**M25 junction 10/A3 Wisley interchange
TR010030**

**9.102 Applicant's Response to
Interested Parties Comments on the
ExA's Third Written Questions**

May 2020

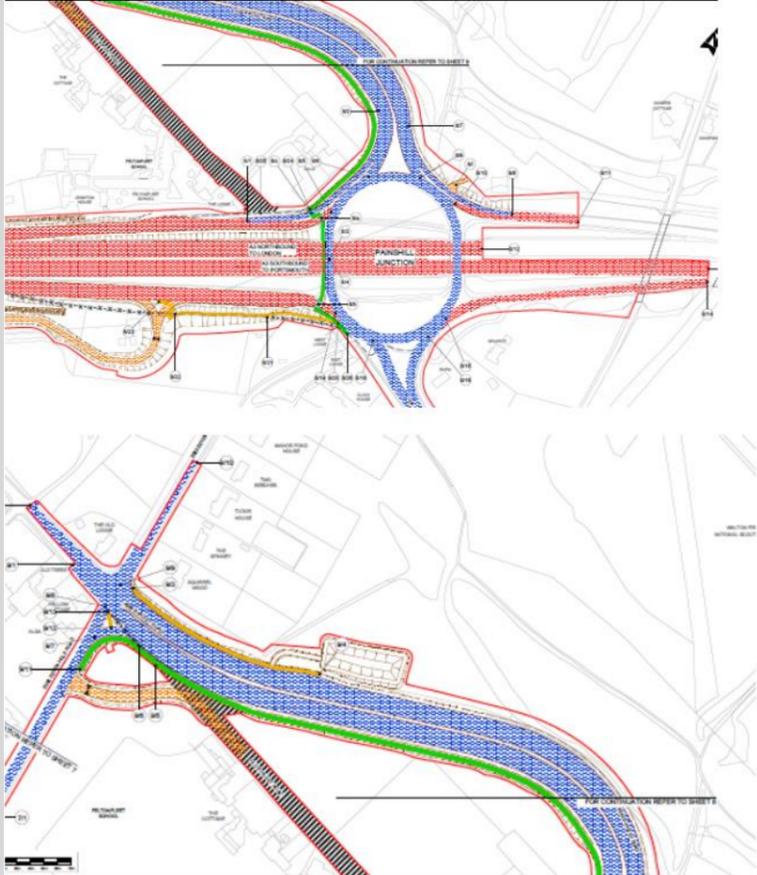
Question No	Question to:	Question:	Interested Party's Response	Highways England
			<p>- The change in journey time for the various movements on the A245 eastbound: e.g. left turn onto A3 northbound slip, straight ahead onto the junction circulatory carriageway and u-turners.</p> <p>3.9 In summary, the level of detail provided is insufficient for SCC to fully comment on the proposed revision. In addition to the modelling requests made above, SCC also require a copy of the RSA along with more detailed drawings in order to fully understand the lane details at the A245/B265 junction specifically.</p> <p>Change 4 - Amendments to Saturday construction working hours</p> <p>4.1 As set out in the latest SoCG REP5-009, SCC support the principle of reducing the overall time period for construction of the project.</p> <p>4.2 As set out in Joint Authorities Local Impact report, however, this is dependent upon Highways England's agreement that the M25 junction 10 Scheme should be subject to the South East Permit Scheme (SEPS). SEPS, in accordance with the Traffic Management Act 2004, provides for highway authorities to co-ordinate works affecting the highway, discharging the duty to maintain the highway network under the New Roads and Street Works Act 1991. Those wishing to undertake works affecting the highway are required to obtain a permit before carrying them out.</p> <p>4.3 SCC would ask that Highways England consider the potential impact on local residents and businesses and how this would be mitigated?</p> <p>Change 5 - Amendment to the speed limit at Elm Lane (and including Byway 525 – Byway Open to All Traffic). Stated as Change 6 in Highways England letter dated 4th November 2019 doc AS-023.</p> <p>5.1 As set out in para 7.8 of Joint Authorities Local Impact report SCC welcomes the proposed change to dDCO submitted on 4th November 2019 (Change 6 of AS-023) that amends the speed limit to 20mph on Elm Lane.</p>	<p>3.9 – Highways England has responded with more detail above to the modelling requests, the RSA will be shared when available and drawings were included with the change application.</p> <p>4.1 SCC's support is noted and welcomed.</p> <p>4.2 Following discussions between SCC and Highways England, Highways England has decided that it will adhere to the South East Permit Scheme not least to assist SCC in the efficient allocation of road space for works. Due provision is made in the dDCO submitted at deadline 8 {REF}</p> <p>4.3 – The working hours change will not cause any different significant environmental effects to those described in the environmental statement for the scheme. This is explained in section 5 of the Report on Proposed Scheme Changes 7-9 [REP7-016]. Paragraph 5.5.1 of that report explains that the placing of topsoil within the worksite will mitigate any additional noise and /or visual effects. No specific mitigation for local residents and businesses is necessary beyond that already provided for, not least in the proposed requirement (requirement 3 in Schedule 2 of the dDCO) for a construction environmental management plan (CEMP) to be approved by the Secretary of State in respect of the construction works. A revised version of the outline CEMP (to form the basis of the operative, approved version) was submitted at deadline 7 [REP7-014]</p> <p>5.1 Highways England acknowledge SCC's support for this change as suggested by SCC.</p>

Question No	Question to:	Question:	Interested Party's Response	Highways England
			<p>5.2 SCC would welcome comments from Highways England as to how actual speeds along Elm Lane would meet the amended/posted speed limit to reduce the impact on amphibians crossing the new section of Elm Lane.</p> <p>Change 6 - Adjustments to the Order limits in the draft development consent order to accommodate the diversion of a gas main.</p> <p><i>This change will result in changes to the impacts on SCC's land holdings, including additional land to be used temporarily and rights to be acquired permanently. The County Council has no comment to make on this change, beyond the point that SCC would require suitable financial compensation for the impact upon SCC affected land. In respect of biodiversity impacts SCC recommend this additional work is covered by a method statement covering both working and reinstatement subject to the consent from Natural England.</i></p>	<p>5.2 – The new section of Elm Lane between Elm Corner and Old Lane will be a single-track road, 3m wide, with passing places, as a result the traffic speed is not anticipated to exceed the posted speed limit of 20mph.</p> <p>The speed restriction on Elm Lane is in addition to the provision of toad underpasses along Old Lane.</p> <p>Highways England acknowledges that SCC is entitled to compensation for land taken or used for the purposes of the Scheme according to the terms of the DCO.</p> <p>This additional work will become part of the wider DCO scheme and will therefore be covered under the wider Precautionary Methods of Working that will be implemented during construction, and the habitat reinstatement will be covered under requirement 17 of the draft DCO.</p>

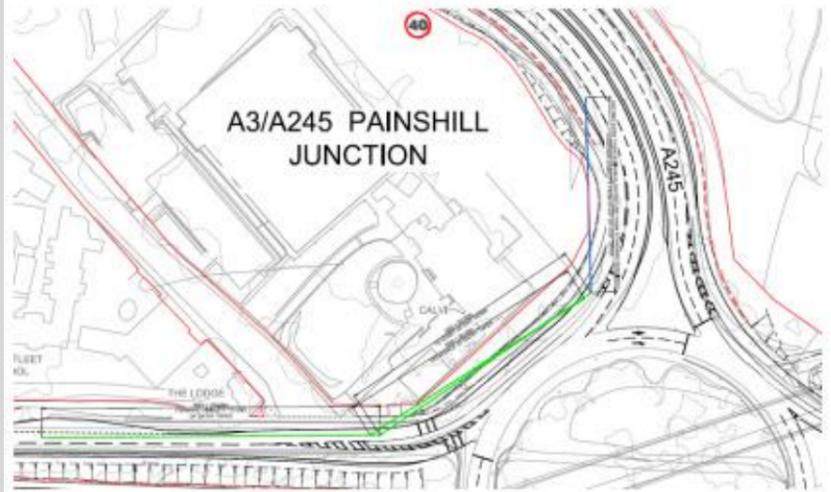
Question No	Question to:	Question:	Interested Party's Response	Highways England
		<p>Applicant and SCC to decide between themselves which organisation is best placed to undertake the modelling that the ExA is requiring to be undertaken. Should the Applicant and SCC be unable to agree which organisation should take the lead on which one undertakes this modelling then it will be for both the Applicant and SCC to undertake this modelling.</p>	<p>would be effectively unchanged compared to the Do minimum scenarios.</p> <p>5. With the DCO Scheme plus south-facing slips there is a significant reduction in the forecast increase in traffic on Old Lane between the Wisley Airfield site access and the A3 as a result of the rerouting of Wisley Airfield generated traffic heading for the A3 southbound via Old Lane to instead utilising the south-facing on-slip (southbound) via Ockham Park junction.</p> <p>6. It is not known what the impact of the slips might be on other movements that presently or in the future would travel through villages such as Ockham, Effingham, East and West Horsley and Pyrford.</p> <p>7. With the DCO scheme and south facing slips at Ockham Park interchange it is forecast that in 2022 up to approximately 900 vehicles per day would use the off-slip and 700 vehicles per day would use the on-slip road , with less than 85 vehicles per hour using each slip road in any peak hour.</p> <p>8. With the DCO scheme and south facing slips at Ockham Park interchange it is forecast that in 2037 this increases to approximately 2,750 vehicles per day utilising both the off and on slip roads, mostly due to traffic generated by the Wisley Airfield development, with between 150 and 350 vehicles per hour using each slip road in any peak hour.</p> <p>However, SCC do have some further questions and comments on the above, as follows:</p> <p>1. It is unclear what modelling HE are referring to when they state that 'Final reporting of the results of this traffic modelling will be provided at Deadline 8': is it the spreadsheet model or modelling using HE's strategic model? SCC assume the outputs available are based on the former, but it is suggested this is clarified. However, if the full reporting is to be based on other modelling then this should be explained as the outputs will change.</p> <p>2. The outputs are reported are very much based on the assumptions made. For example, output (3) states that all Wisley Airfield traffic heading for the A3 south would utilise the A3 s/b on-slip as opposed to using Old Lane. However, in reality, it is likely to be only a proportion of these trips, albeit potentially the majority that would utilise the new on-slip as other trips might still find the use of the Old Lane junction to access the s/b A3 more convenient depending upon their origin within the development. Consequently, it is the assumptions made driving the outputs rather than the modelling: the spreadsheet model is more a means of displaying these assumptions and the resulting change in</p>	<p>1) As stated by SCC, their responses refer to a spreadsheet model developed by Highways England and shared with SCC to enable this answer to be drafted in time. In the event, answers were available from the strategic traffic model and these were presented as Highways England's response to this question.</p> <p>2) See point 1 above. The comments made by SCC here refer to the spreadsheet model and not outputs from the strategic highway model.</p>

Question No	Question to:	Question:	Interested Party's Response	Highways England
			<p>flows rather than anything more complex. While SCC does not disagree with this approach and concurs it is an appropriate method given the time constraints, SCC considers that more clarity might be helpful to the ExA. As a simplified approach is being taken to the modelling of the Ockham slips, it is worth noting that should it be deemed useful to model the Ockham slips in conjunction with the additional Burnt Common slips additional assumptions would need to be made informed by some analysis of the existing models, and this would be more involved than the work conducted for the Ockham slips. SCC mention this as it may be helpful to the ExA in raising awareness (if not already known) that the north facing Burnt Common slip roads are now in the Road Investment Strategy 2 (RIS2) as a RIS3 Pipeline project for investigation in RIS2. SCC understand from the RIS2 document that if the study concludes they are feasible and deliverable, the slips could be implemented in the time period 2025 to 2030.</p> <p>SCC and GBC welcome the inclusion of the Burnt Common Slips in RIS2 as they form part of the Guildford Local Plan (Policy A42) and these slips, alongside traffic management measures on B2215, would help to mitigate the impact of Local Plan growth and strategic highway improvements on the village of Ripley.</p>	<p>Highways England will not be modelling Burnt Common slips. The slips are not required as a part of the Scheme and the slips at Burnt Common are only applicable to mitigate development in accordance with Policy A35 of the Guildford Borough Local Plan at the former Wisley Airfield site. Accordingly, this is a matter for the developer of that scheme.</p>
